PA-9 Design of Circular Concrete Manure Tanks using MWPS TR-9, dated November 1983

Use of MWPS TR-9, Dated November 1983

Fig 2. Wall to floor joints.

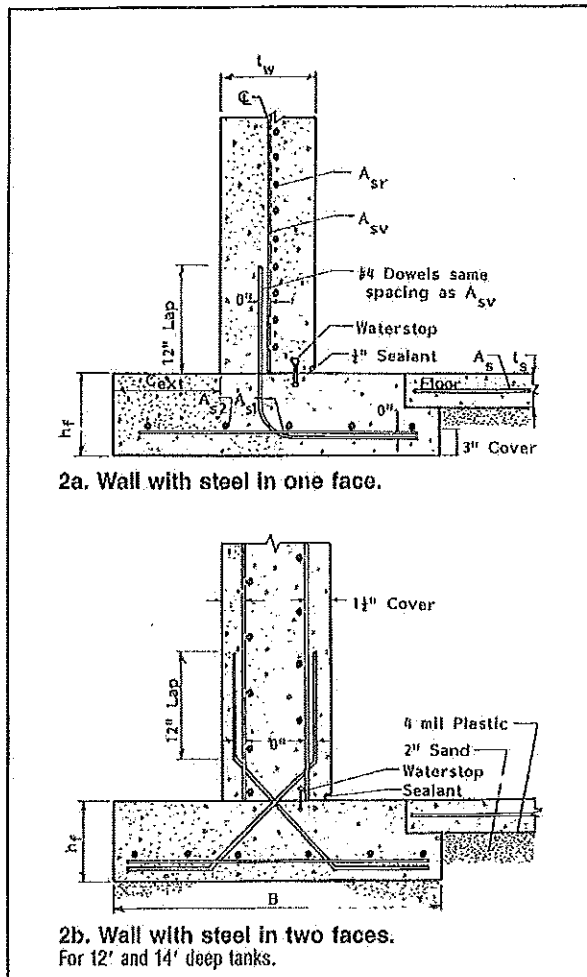
6. Figure 2, floor & footer joint detail can be replaced by attached Supplement to MWPS TR-9, Figure 2 revised 11/13 to allow for monolithic placement of floor and footer and also shows required As for floor. Steel placement is not changed.

SUPPLEMENT TO MAPS TR-9

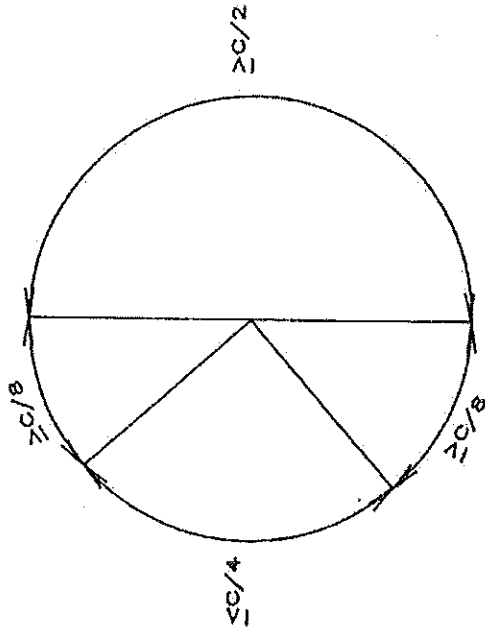
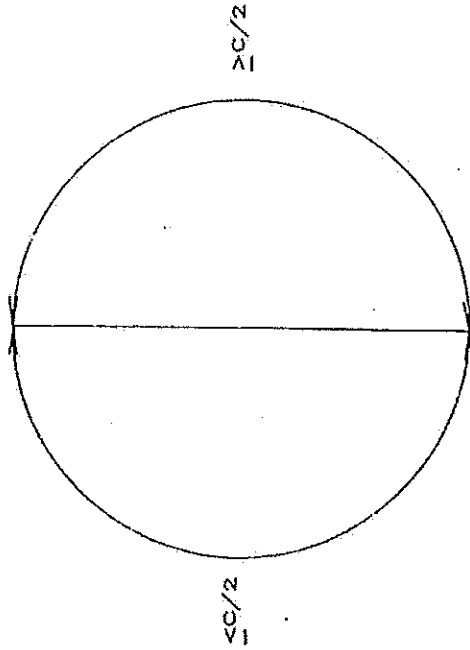
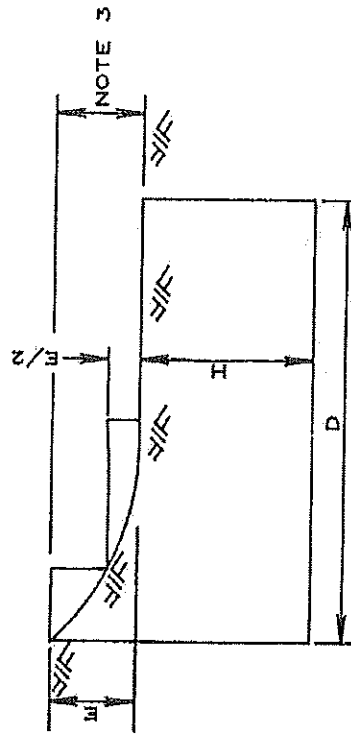
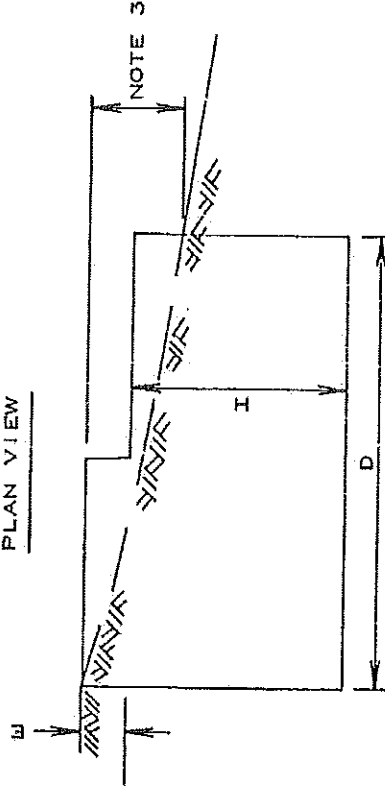
8. The maximal fill differential from one side of the tank to the other is the tank height minus 3 feet for frost protection except for sites with kicker walls. Then the maximum difference from one side to the other is 4 feet. See "Supplement to MWPS" for details on kicker wall.

1. The dimensions shown represent the limitations for the use of "kicker walls" as per PA Bulletin No. PA 210-2-3.
2. The reinforcement steel on the extension height (E) is the same as that in the top section of the design height (H).
3. Maximum backfill differential is 4 feet.
